CRUISER
AIRCRAFT

No.: SB-SC-103

SERVICE BULLETIN

MODEL AFFECTED:	SportCruiser / PiperSport operating outside EASA rules
SUBJECT:	Accomplishment of ROTAX Bulletin SB-912-077UL / SB-912-077. Exchange of stator assy. for ROTAX 912 Aircraft Engines.
AIRCRAFT AFFECTED:	All aircrafts with 912 S and 912 ULS engines.
COMPLIANCE:	-On undelivered engines prior to delivery -Before the initial installation in an aircraft and/or spare part -Carry out this exchange of the stator on the engines listed in APPLICABILITY, according to the instructions in section 3 at the next ROTAX scheduled maintenance event, but at the latest after 1 year (from the date of the initial issue of this SB) These maintenance instructions shall be considered at any maintenance events, retrofitting, repair and overhaul.

Fig. 1: Pullers

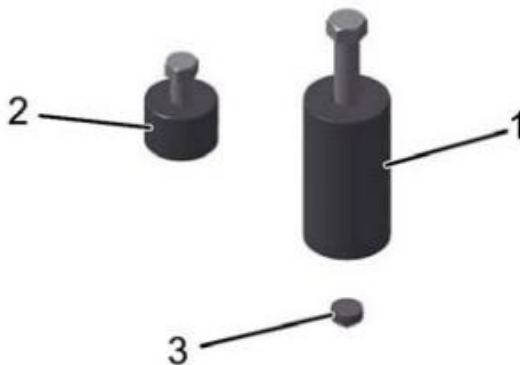
*Depending on the installation situation 2 variations of the puller assy. of different length are available. See Fig. 1.

Fig. 2: Screws

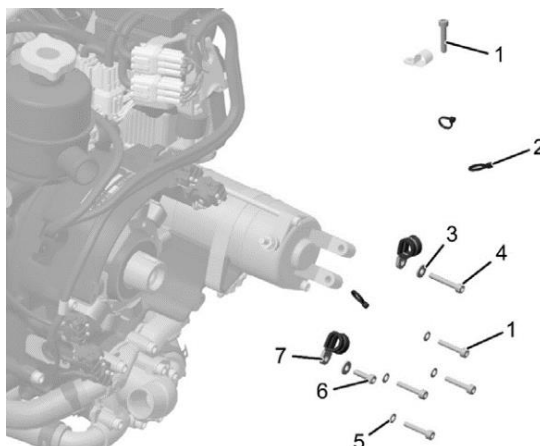
- 1 part no. 240187 Allen screw M5x25
- 2 part no. 866710 Tie wrap 142x2.5 mm
- 3 part no. 945830 Lock washer A5
- 4 part no. 940882 Allen screw M5x30
- 5 part no. 945830 Lock washer A5
- 6 part no. 840514 Allen screw M5x16
- 7 part no. 851250 Cable clamp 15/M5

Fig. 4: Gap trigger coil.

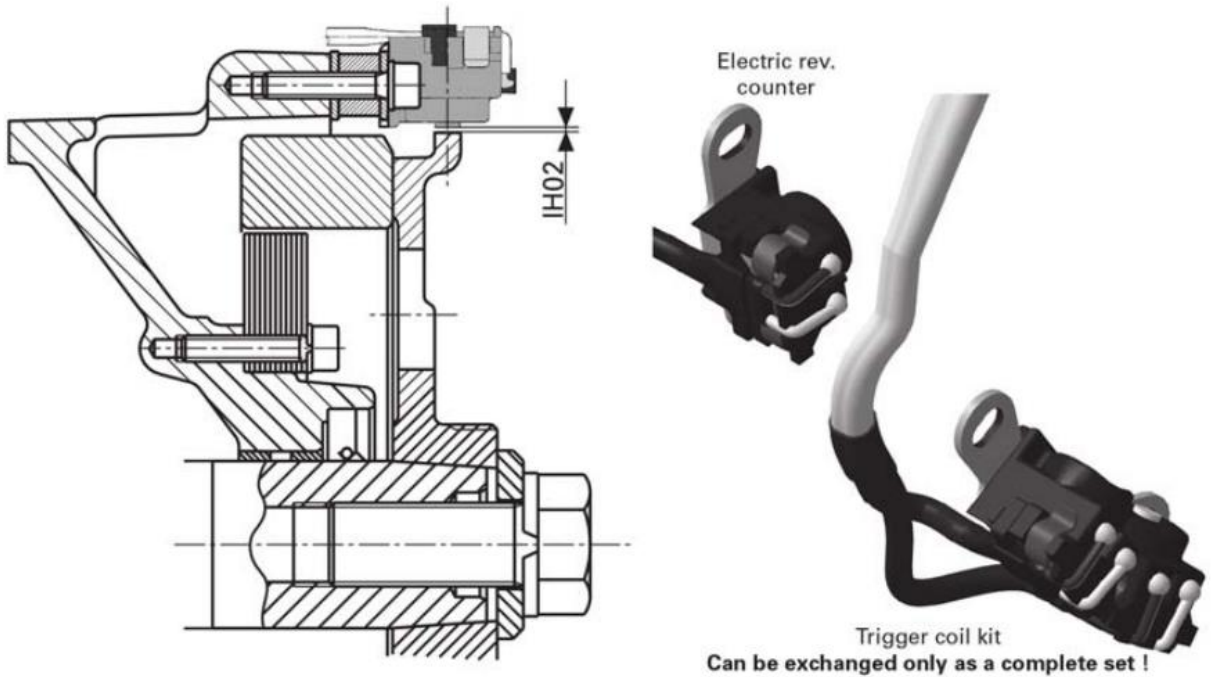
DESCRIPTION	CODE	READING NEW		WEAR LIMIT		READINGS				
		min.	max.	100%	50%		A 1/2	A 3/4	B 1/2	B 3/4
Trigger coil gap "old type"	IH02	0.4 mm (0.016 in)	0.5 mm (0.02 in)			actual				
Trigger coil gap (with clamps)	IH02	0.3 mm (0.012 in)	0.4 mm (0.016 in)			renewed
